Service Bulletin

Bulletin No.: 17-NA-140

Subject: Rattle Noise from Rear of Vehicle and/or Wind or Buffeting Noise While Driving with One Window Lowered

Brand:	Model:	Model Year:		VIN:		Engine:	Transmission:
		from	to	from	to		
Chevrolet	Camaro	2016	2021	—		All	All

4773146

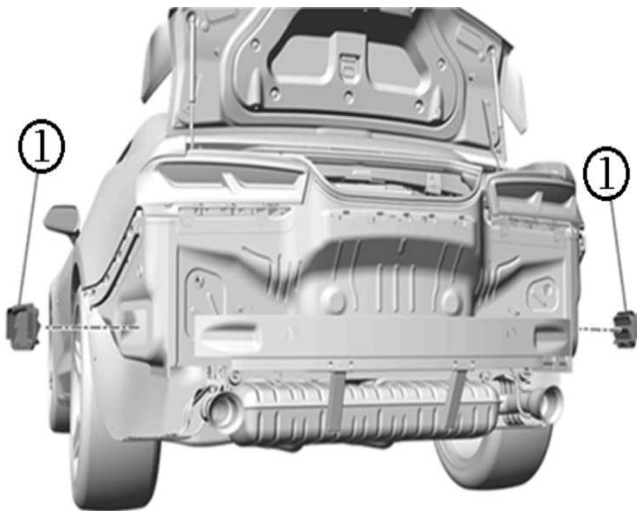
For vehicles exhibiting this condition, replace both of the original body pressure relief valves (1) with two of the four-flap design valves listed in the Parts Information table. Refer to *Body Pressure Relief Valve Replacement* in SI.

Description	Part Number	Qty
VALVE, QTR OTR PNL PRESS RLF	22788177	2
